MIL-PRF-19500/673
AMENDMENT 1
20 August 2001

PERFORMANCE SPECIFICATION

SEMICONDUCTOR DEVICE, FIELD EFFECT RADIATION HARDENED (TOTAL DOSE AND SINGLE EVENT EFFECTS) TRANSISTOR, N-CHANNEL, SILICON TYPES 2N7468U2 AND 2N7469U2 JANTXVR, F, G, AND H, AND JANSR, F, G, AND H

This amendment forms a part of MIL-PRF-19500/673, dated 9 March 2001 and is approved for use by all Departments and Agencies of the Department of Defense.

FIGURE 2. Thermal response curve. ”

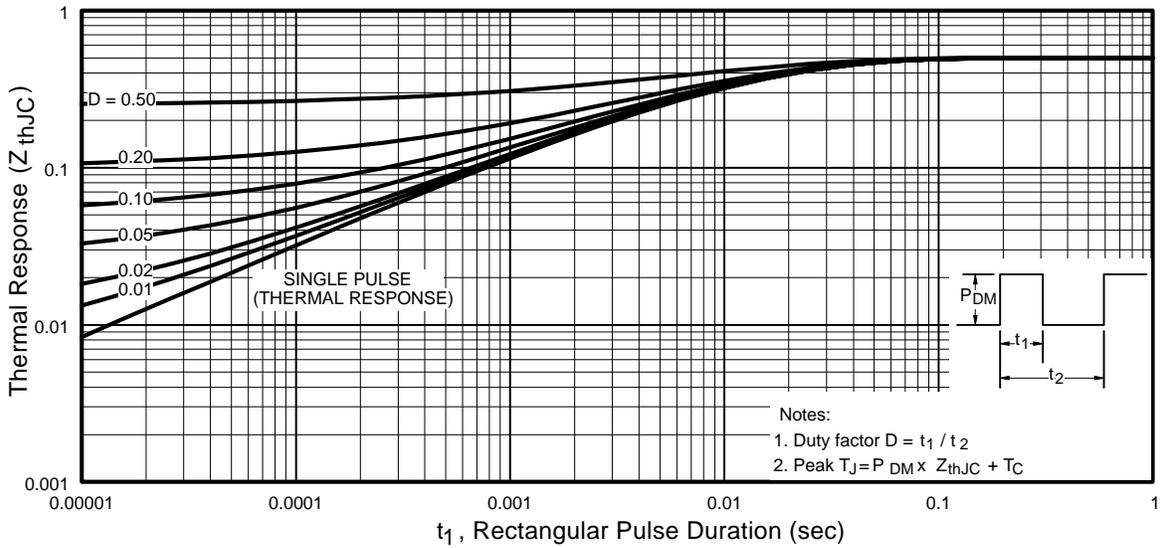
FIGURE 2, delete and substitute:

FIGURE 3. Safe operating area graph. "

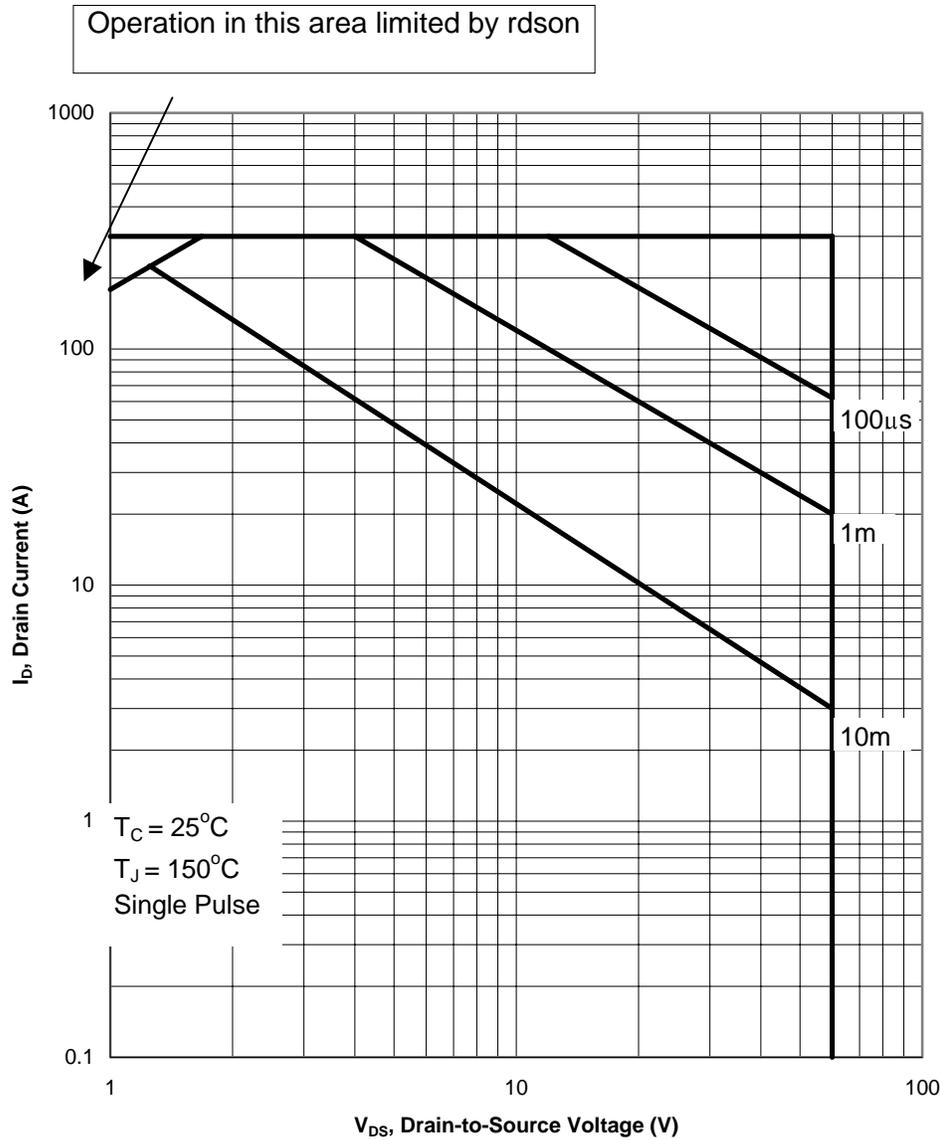
FIGURE 3, delete and substitute:
“

FIGURE 4. Safe operating area graph. "

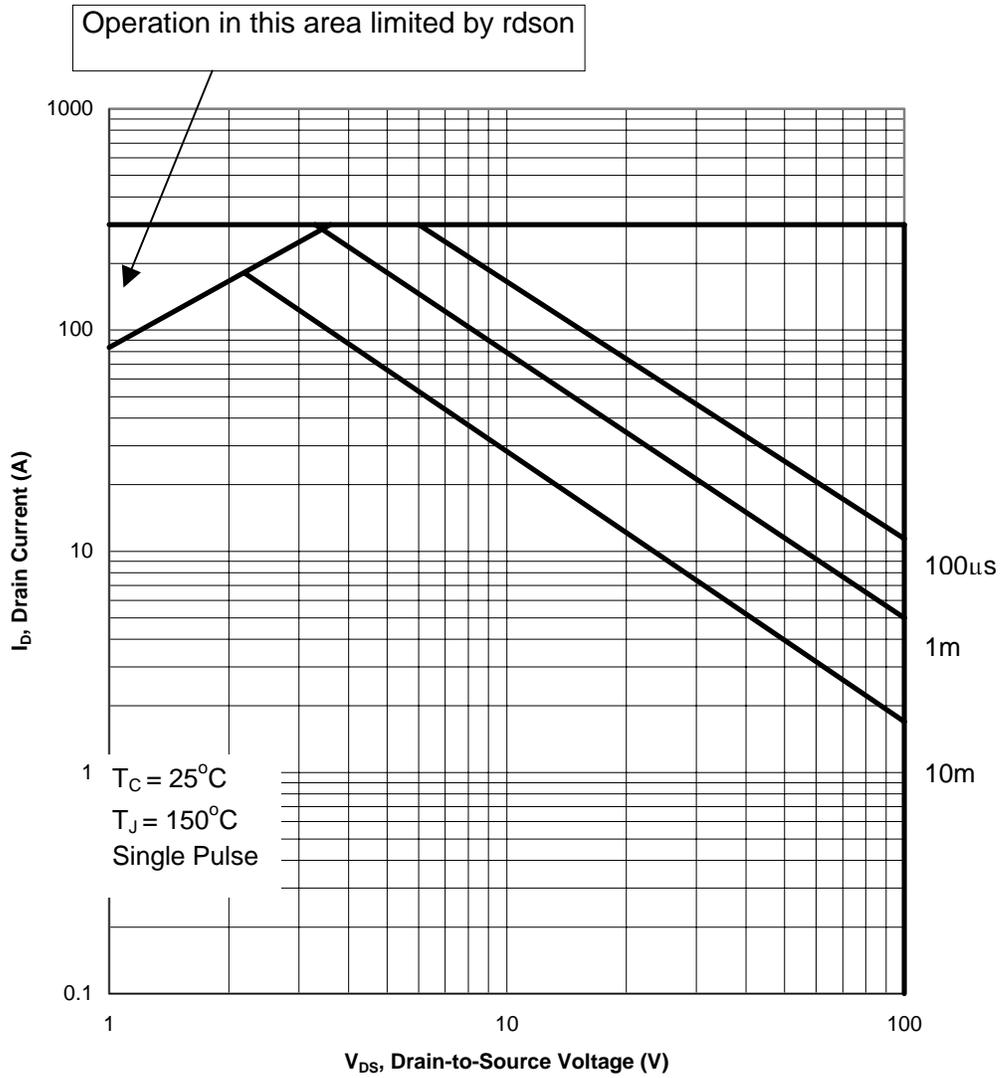
FIGURE 4, delete and substitute:
"

FIGURE 5. SEE safe operating area graph. ”

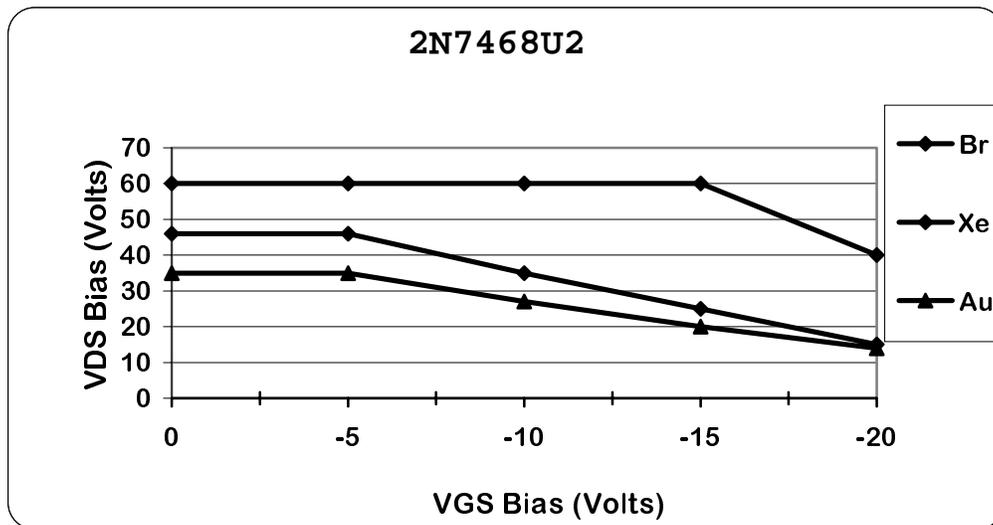
FIGURE 5, delete and substitute:
